**Re: North American Electric Reliability Corporation
Docket No. RM__ - __ - __
Petition of the North American Electric Reliability Corporation for Approval of a
Revised Definition of “Bulk Electric System” in the NERC Glossary of Terms
Used in Reliability Standards**

**PETITION OF THE
NORTH AMERICAN ELECTRIC RELIABILITY CORPORATION
FOR APPROVAL OF A REVISED DEFINITION OF “BULK ELECTRIC SYSTEM”
IN THE NERC GLOSSARY OF TERMS USED IN RELIABILITY STANDARDS**

Consideration of Comments on Definition of the Bulk Electric System (BES) Technical Principles for Demonstrating BES Exceptions — Project 2010-17

Diagram below refers to BGE comment for Q7:

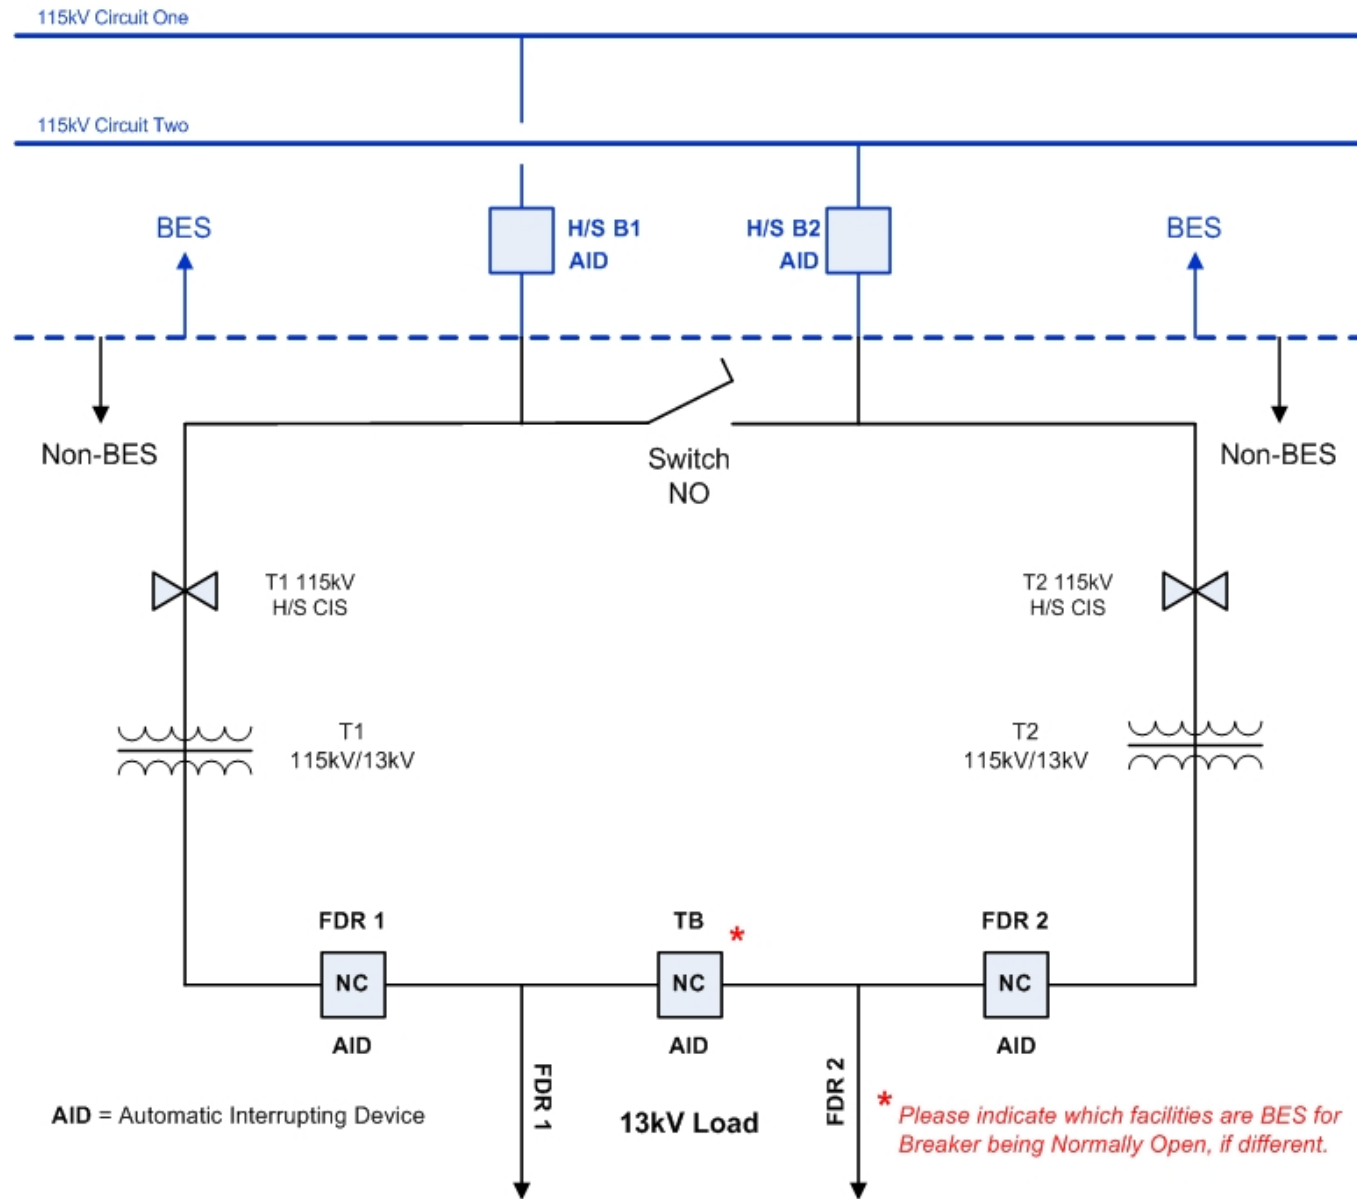
Organization	Yes or No	Question 13 Comment
<p>shown below. <u>This does not include facilities used in the local distribution of electric energy.</u></p> <p>Comments concerning the Technical Principles (Exception Criteria) associated with the RoP Exception Process will be addressed through the dedicated responses developed by the SDT and published in the specific Consideration of Comments document associated with that portion of the overall project.</p>		
<p>Modern Electric Water Company</p>		<p>1) The SDT states that “one of the basic tenets that the SDT is following is to avoid changes in registration due the revised definition”. We stress the implications of a missed opportunity and the importance of a usable BES definition, because if the revised definition does not allow the industry (both registered and non-registered entities) as well as the regional reliability organizations to focus on and conduct business in a fashion that promotes reliable and efficient system operation (not just ultra-conservative compliance monitoring), then NERC has failed to do its job in this particular instance.</p> <p>2) The proposed implementation plan indicates that the effective date of this definition is not for at least 24 months after regulatory approval. We strongly disagree with this suggested approach as it does not provide for any benefit from this much-needed improvement. We believe the SDT intended to imply that entities not currently registered would have at least 24 months to become compliant with applicable standards if the improved BES definition suddenly swept them into the BES as it did for many small utilities on June 18, 2007. The definition should become effective immediately upon regulatory approval, and transition plans for newly-registered entities could specify longer timeframes.</p> <p>3) As currently drafted, NERC’s Statement of Compliance Registry Criteria (Revision 5.0) contains the text of NERC’s approved BES definition. Upon approval of any other language, the SCRC will become inaccurate without review and modification.</p>

<p>Response: 1) The goals and assumptions established by the SDT are based on the documented Commission expectations in Orders Nos. 743 & 743a. Opportunity does exist to further revise the definition beyond the clarification identified by the Commission in the Orders, however, technical justification is required to deviate from the current application of the current BES definition. No change made.</p> <p>2) The SDT agrees with the commenter and has made revisions to the Implementation Plan to address these concerns surrounding the implementation dates.</p> <p>3) Review and potential revision of the NERC Statement of Compliance Registry is beyond the scope of the current SAR for this project. No change made.</p>

Figure 1 (Inclusion I1):

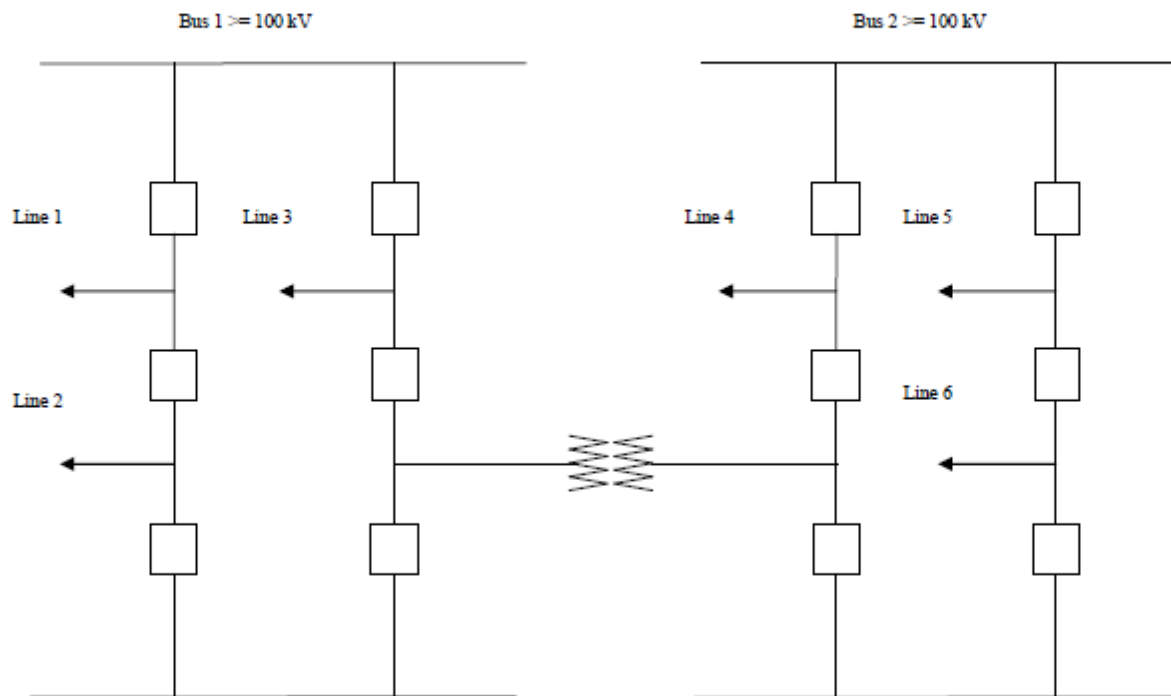
Rochester Diagrams: These diagrams were supplied by Rochester as examples and do not reflect the SDT's opinion of what is and isn't a BES Element.
